Gachsaran Polymer Industries Company HDPE Plant		
	LCP and Junction Box Layout, Arrangement and Wiring Drawing for Refrigerator Package		 
PO No.: GPIC-PT-MA-PO-000-3029	Document Number: VD-GPIC-MA-3029-3029-0046	Rev. 00	Page 1 of 14

LCP and Junction Box Layout, Arrangement and Wiring Drawing for Refrigerator Package

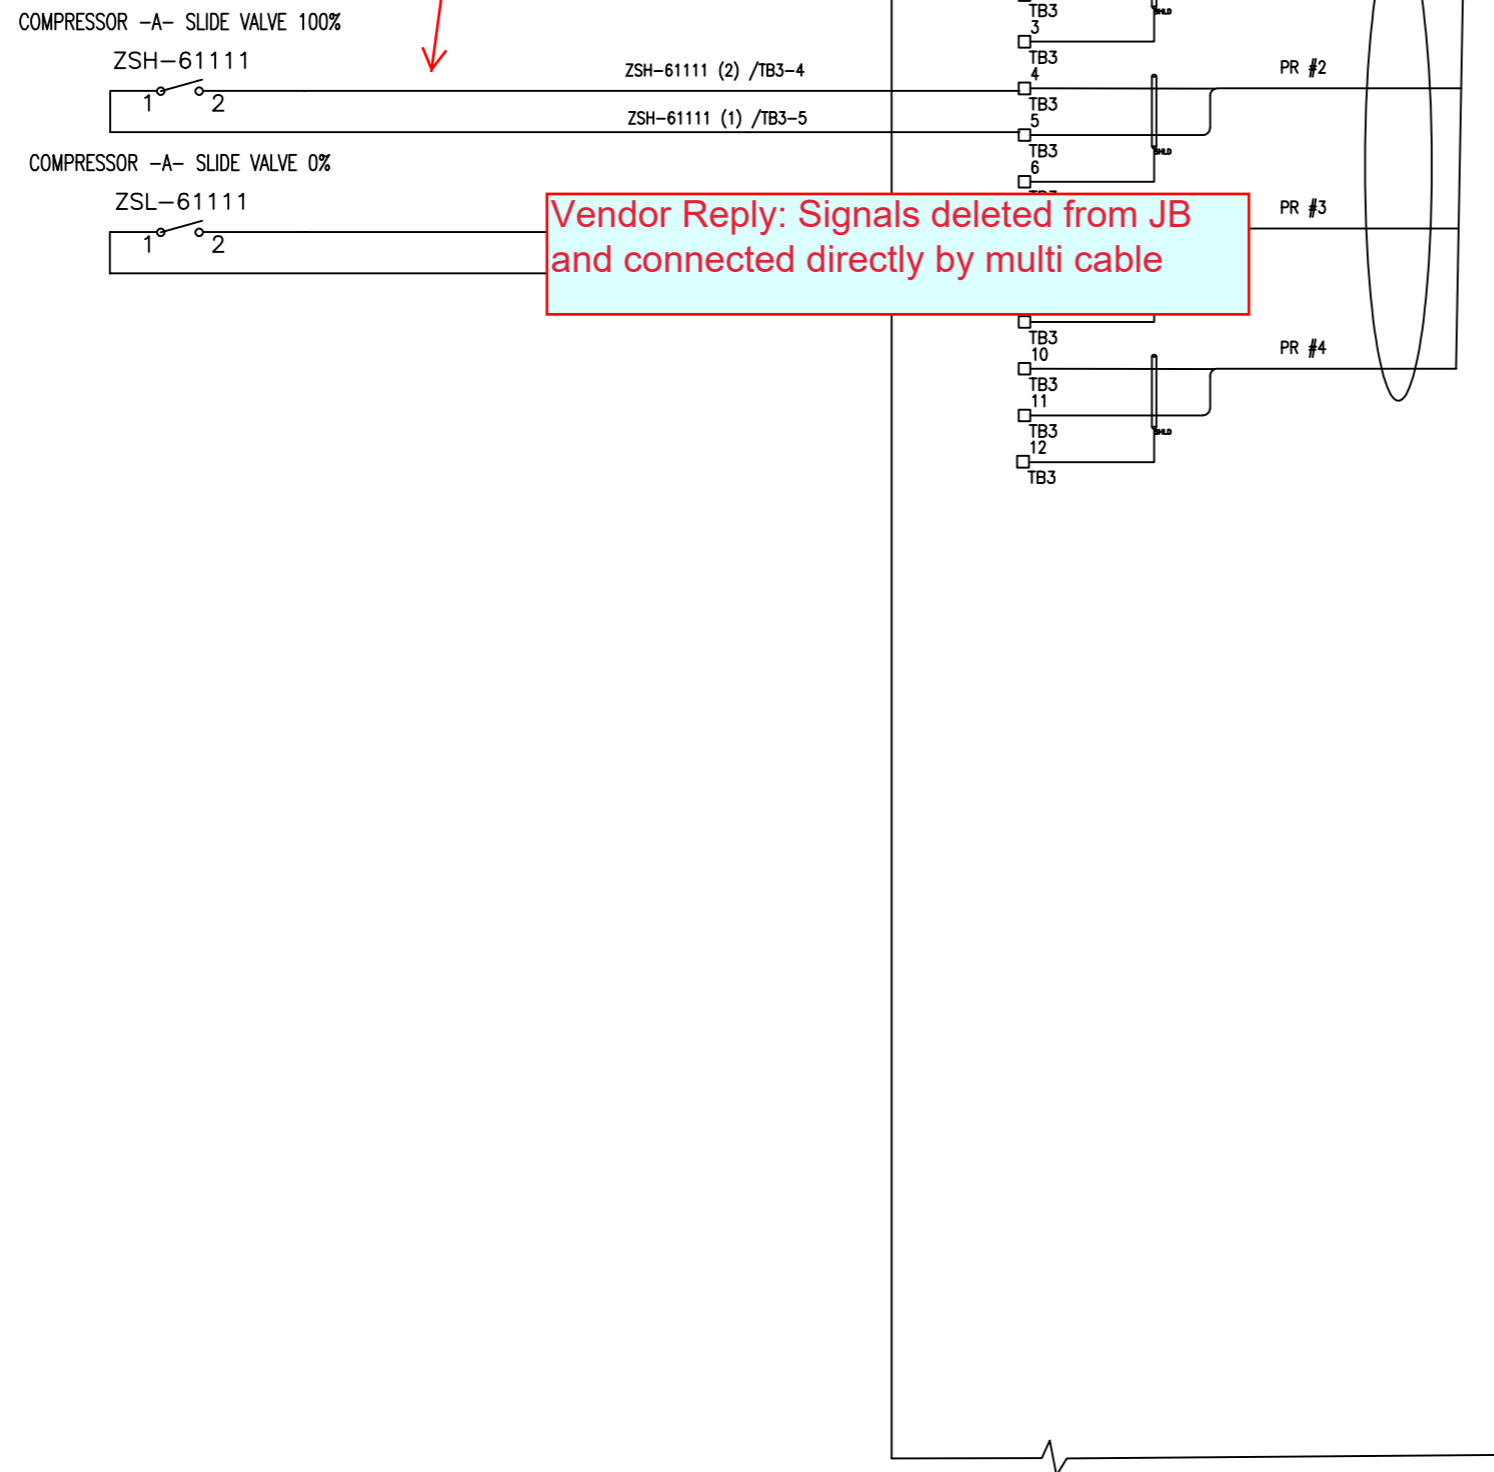
Tag number of digital JB shall be UID.
 Separated JB for digital signals shall be considered.
 It is not acceptable that 2 multi-pair cables are connected to one JB.

"FRT-01Px1.5mm² OSCR/SWA/IS/BLUE (300/500)"
 for all single pair cables.

Delete it.

Add cable tag: IC-UID-611

Vendor Reply: Signals deleted from JB
 and connected directly by multi cable

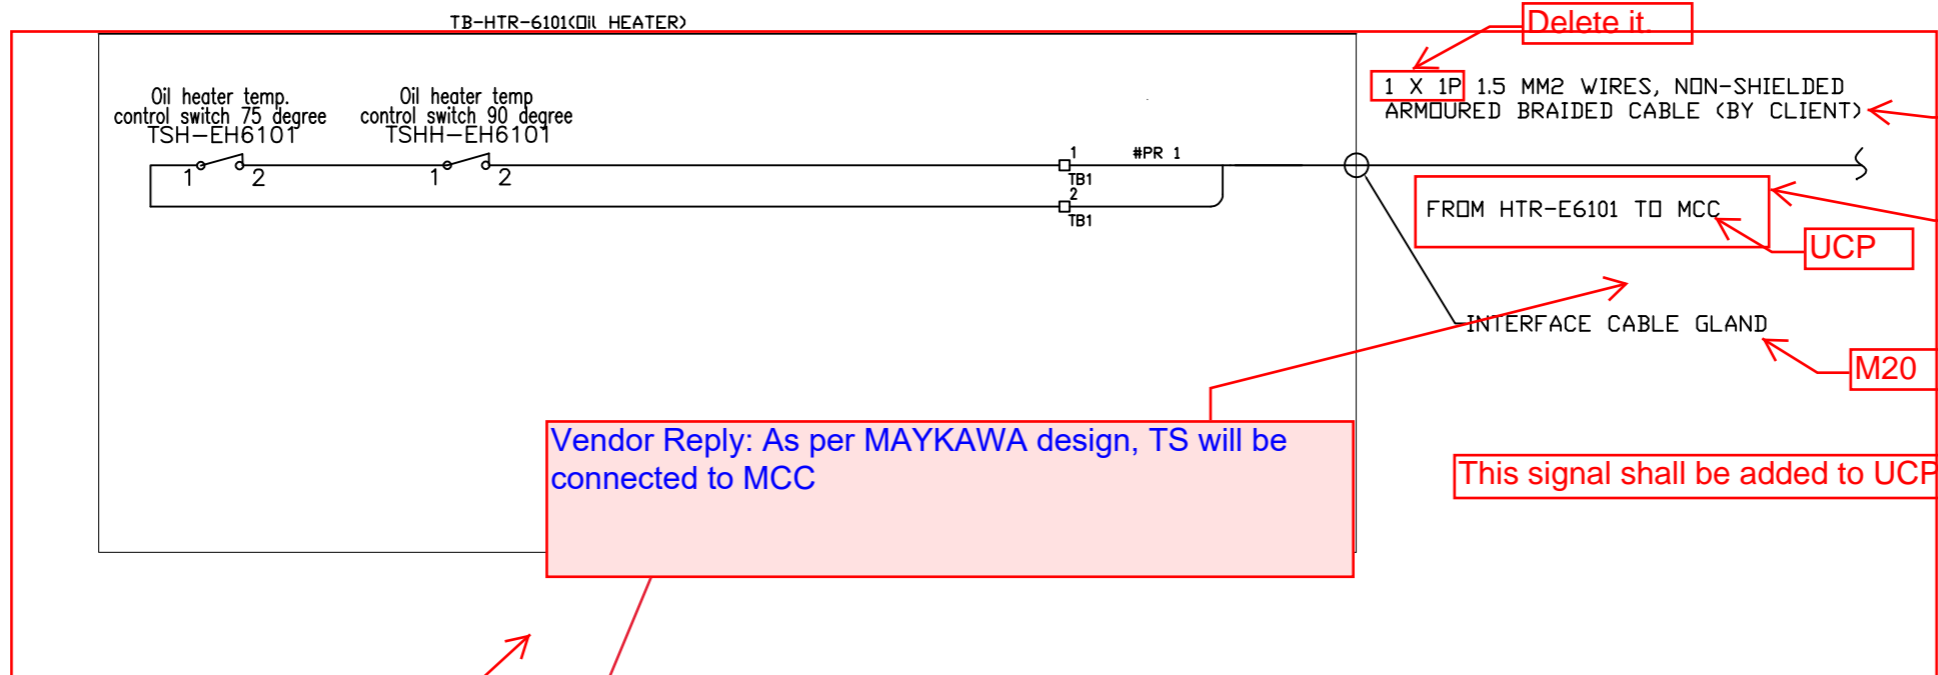
EL03:
 This signal is not in the I/O list and it is not possible to connect it to the MCC. Therefore, first it shall be defined in the I/O list and secondly it shall be connected to the UCP.
